IES UTILITIES INC.

December 21, 1994
NG-94-4632

Subject: Duane Arnold Energy Center
Docket No: 50-331
Op. License No: DPR-49
Response to NRC RAI on MSIV Leakage
Control System Technical Specification
Amendment Request (RTS-232)

**IES RESPONSE
TO NRC
REQUEST FOR ADDITIONAL INFORMATION**

Figure 1-1
DAEC Turbine Building

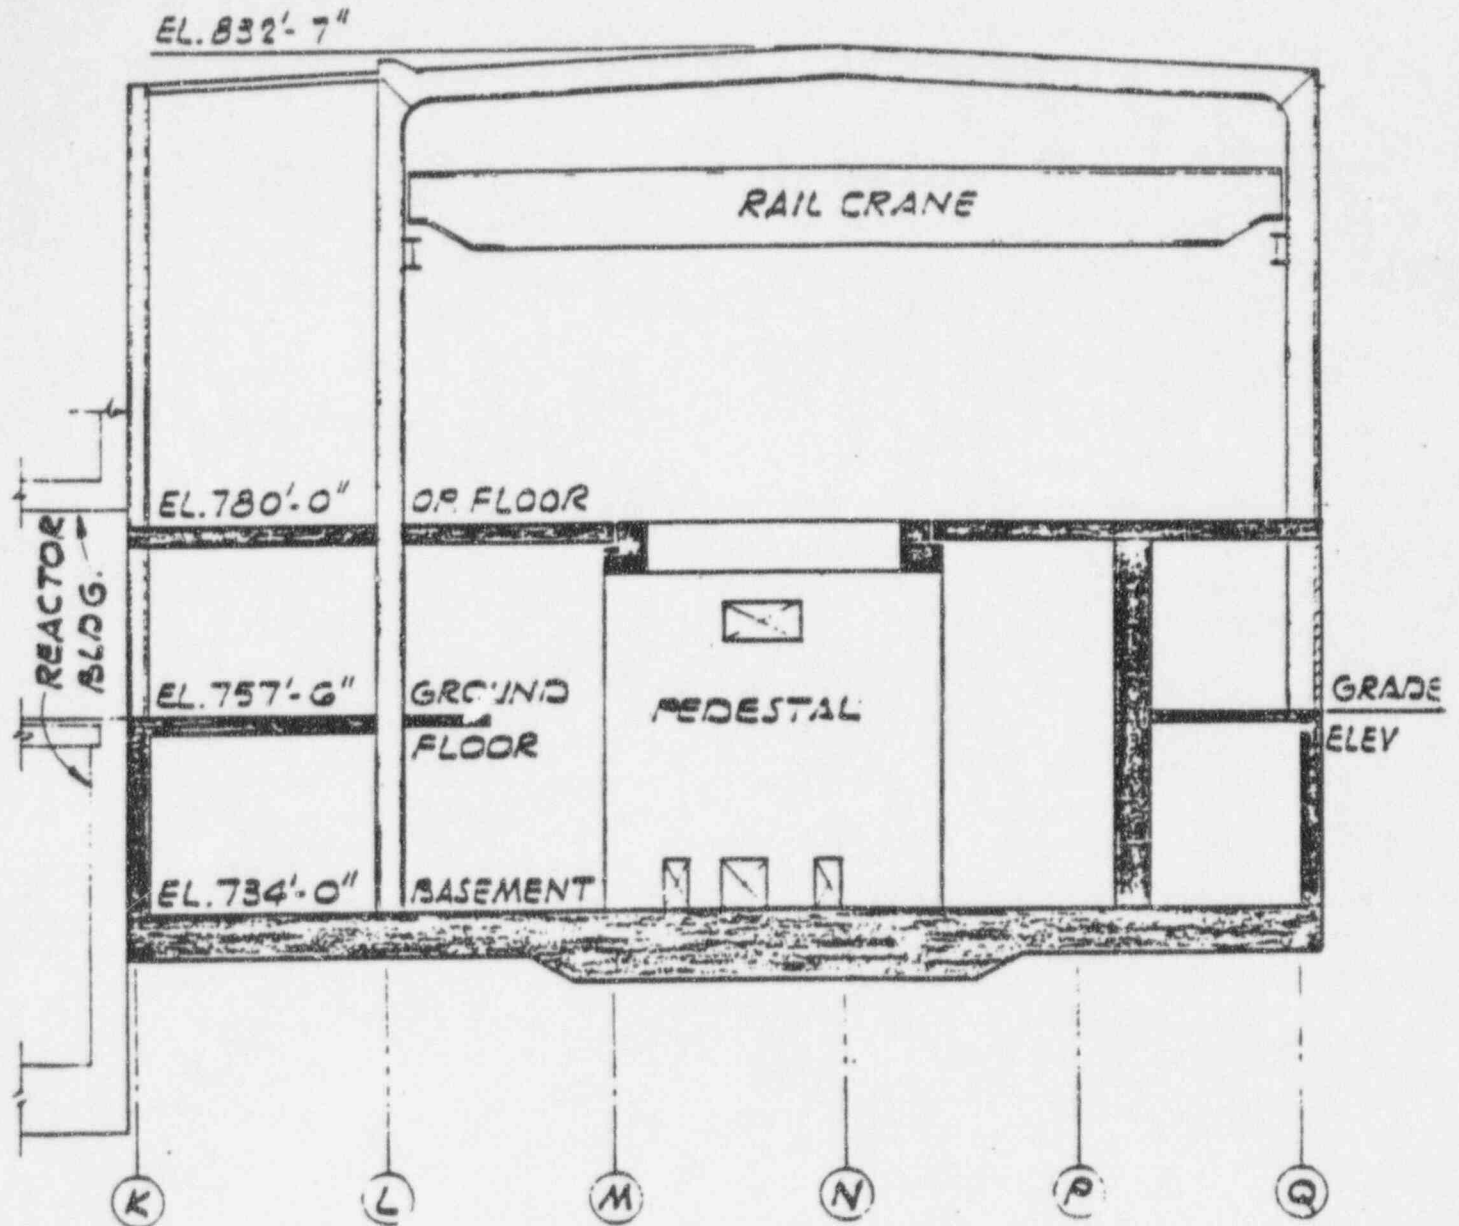
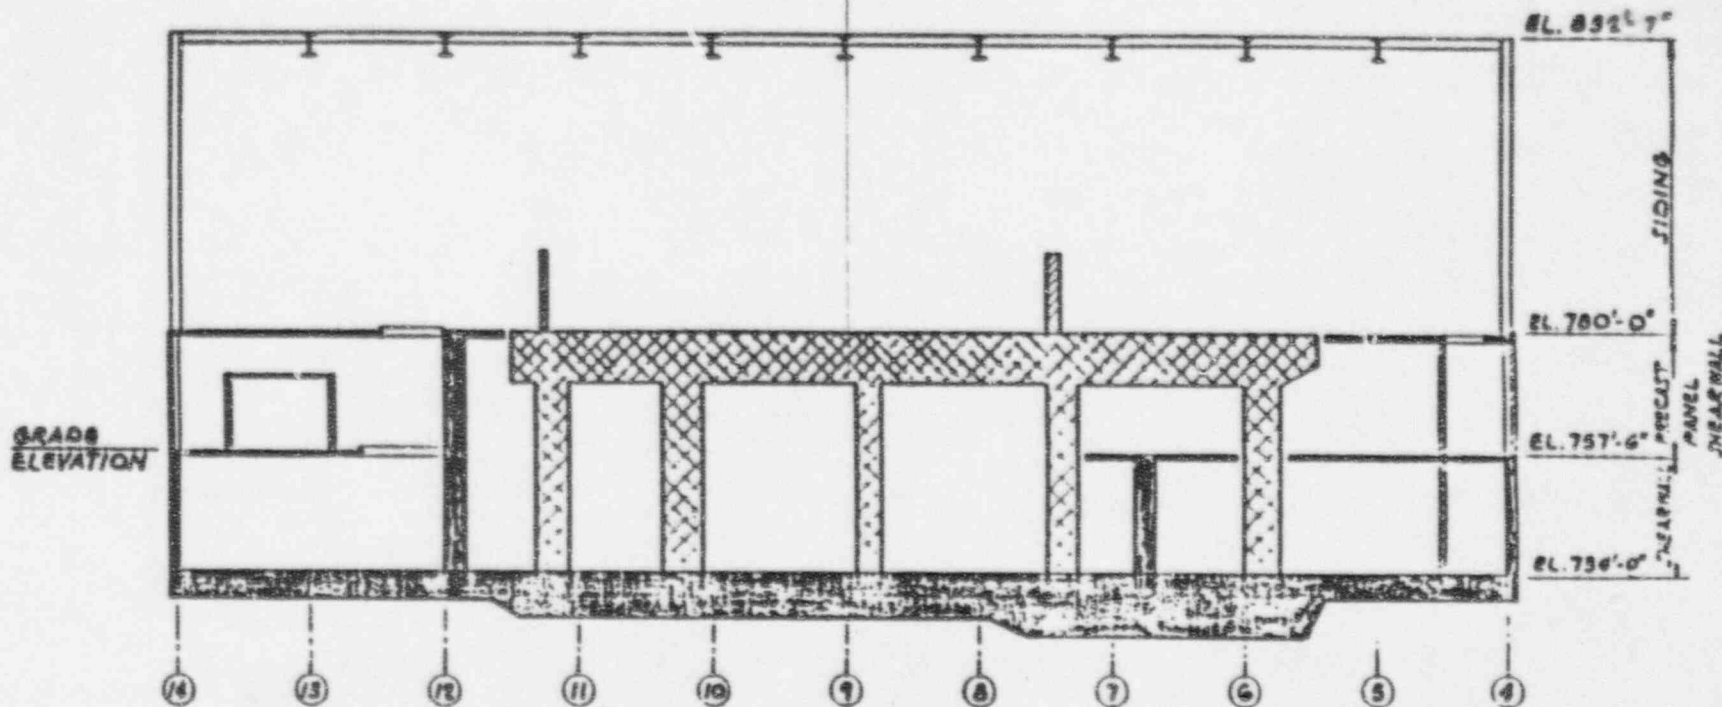
Provide a description of the soil-structure interaction (SSI) analysis performed by the licensee for the turbine building, including the following:

- a. the computer code, the soil model, and structure model used in the analysis;
- b. the input ground motion applied to the model and the location of its application;
- c. the soil parameters used and the way their uncertainty was addressed; and
- d. the way the uncertainty in the structural response was addressed.

The Duane Arnold Energy Center (DAEC) turbine building (Figures 1-1 and 1-2 on pages 1-4 and 1-5) is a three story rectangular structure, 260 ft long by 140 ft wide by 107 ft high. The basemat is founded on about 15 ft of undisturbed glacial till over bedrock. The sides of the turbine building were backfilled with compacted soil up to grade level (approximately 757 ft). The first floor (basement) consists of a reinforced concrete basemat with reinforced concrete walls. The remainder of the structure consists of braced steel frame walls and roof with reinforced concrete floor slabs. A centrally located reinforced concrete turbine pedestal extends from the basemat to the operating floor at elevation 780 ft.

Figure 7-1: D/t Ratios for Duane Arnold
Alternate Drain Path Piping
and Selected Database Piping

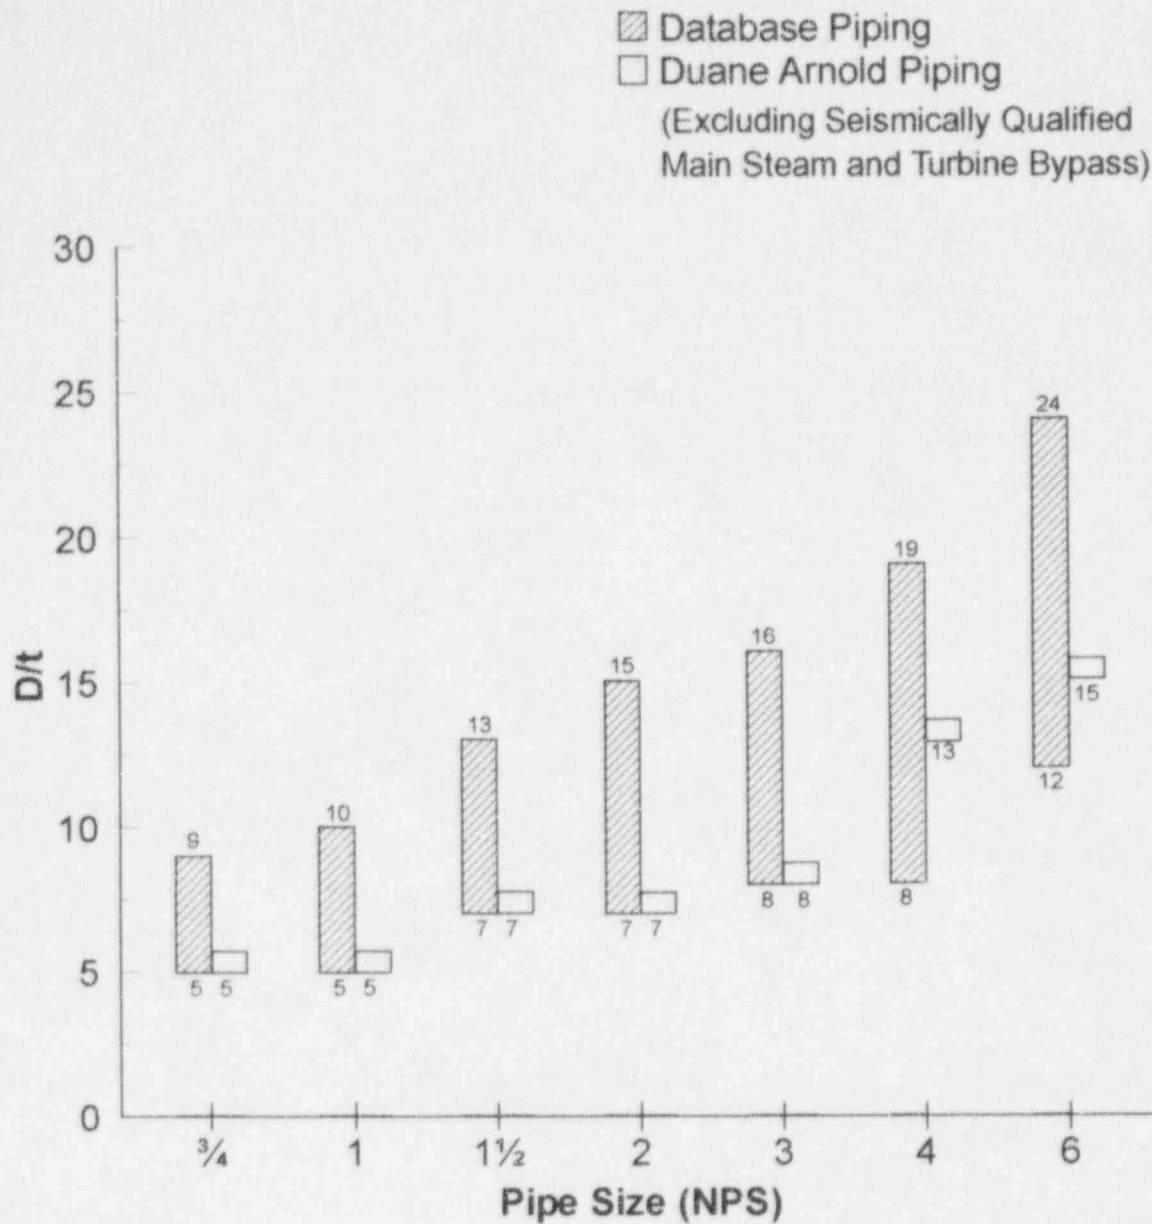
Provide a detailed comparison between the Duane Arnold piping in the alternate leakage treatment path and the pertinent database piping. The comparison should be specific for each of the pipe diameters at Duane Arnold, its associated pipe thickness, and associated pipe diameter-to-thickness ratio.

Table 7-2 shows the pipe diameters, wall thickness and pipe diameter-to-thickness (D/t) ratios for piping at selected database power plant facilities. Additional data on piping in the seismic experience database has been submitted to the NRC in the following documents:

The information in Table 7-2 is a sampling of main steam piping and process piping at selected power plants in the seismic experience database. This represents a small portion of the facilities with power and petrochemical piping which have been studied for the effects of strong motion earthquakes. The range in piping parameters from Tables 7-1 and 7-2 is summarized in Table 7-3 and Figure 7-1. Table 7-3 and Figure 7-1 demonstrate that the DAEC alternate treatment path piping is well represented within database piping.

Figure 3-1: Size Comparison of the DAEC Condenser with Representative Condensers from the Earthquake Experience Database

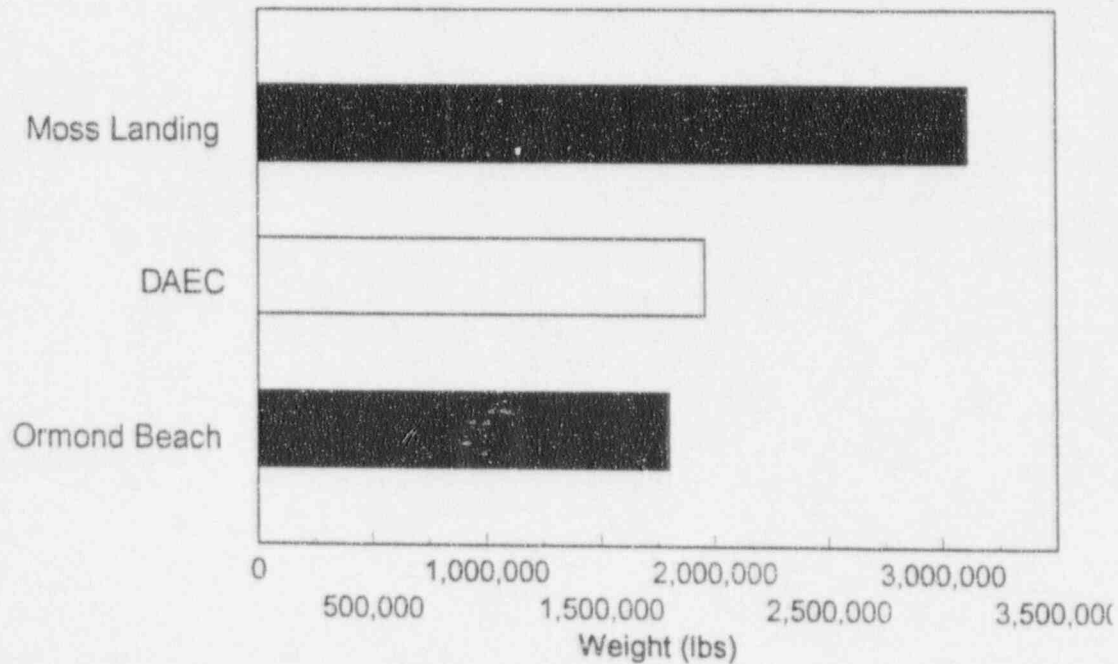
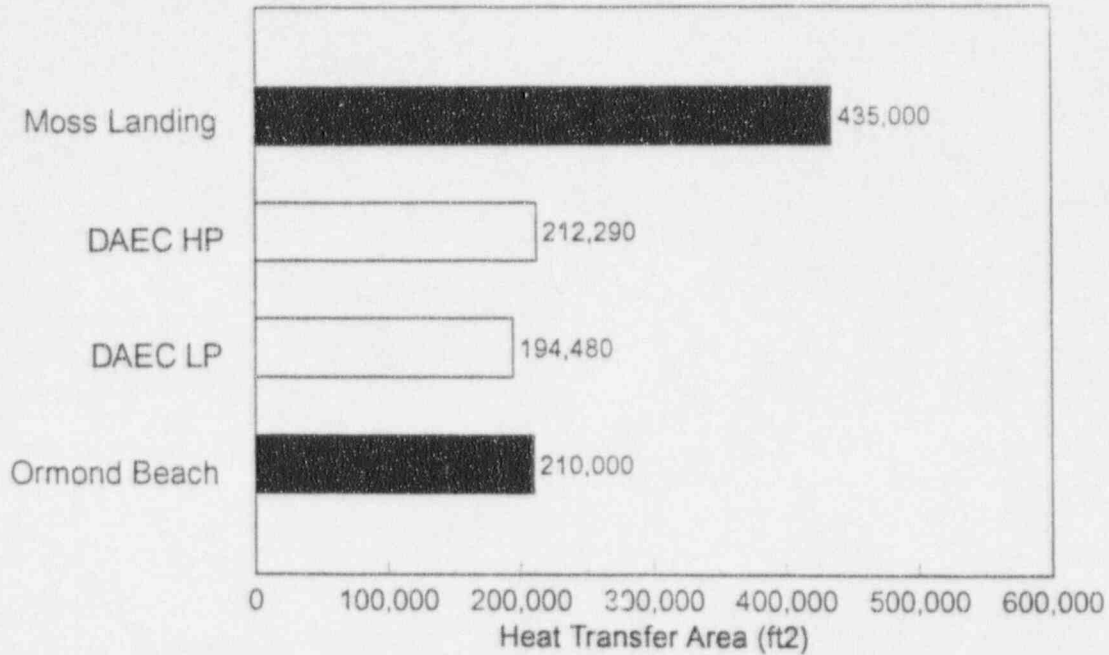
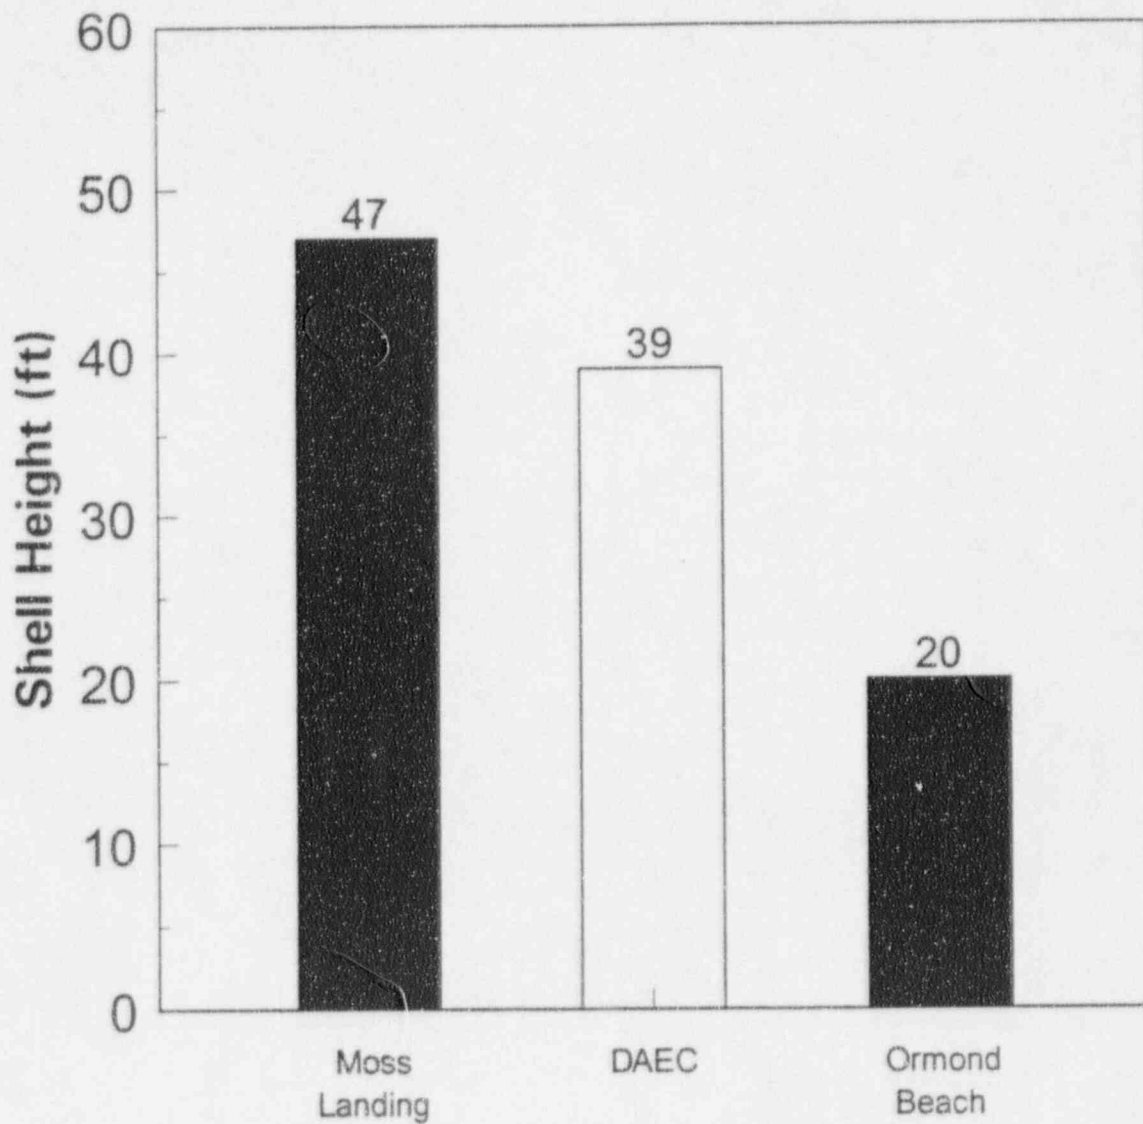
Provide calculations that demonstrate the seismic adequacy of the condenser, by using an acceptable analytical methodology, considering the integrity of pertinent structural members, the seismic demand, and the seismic capability of the condenser support members.

The seismic adequacy of the condenser shell and pertinent internal structural members was based on the earthquake experience database, as documented in the GE topical report (Reference 3). As discussed in our August 15, 1994 submittal (NG-94-2629), the DAEC condensers (one high pressure and one low pressure condenser) are bounded in size, weight, and condensing area by several large surface condensers in the earthquake experience database, in particular Moss Landing and Ormond Beach. (See Figures 3-1, 3-2, and 3-3 of Attachment 7 to the August 15, 1994 submittal, reproduced on pages 13-2 through 13-4.) In addition, the DAEC design basis ground response spectrum is enveloped by the ground motions for the database sites as shown in Figure 3-4 of that submittal, reproduced on page 13-5.

It is the judgment of IES that earthquake experience data and the methodologies provided in the GE topical report provide an acceptable and preferable method for verifying the seismic adequacy of the DAEC condensers which were not originally designed for seismic loads. Accordingly, deterministic calculations were not performed for the condenser shell and pertinent internal support members.
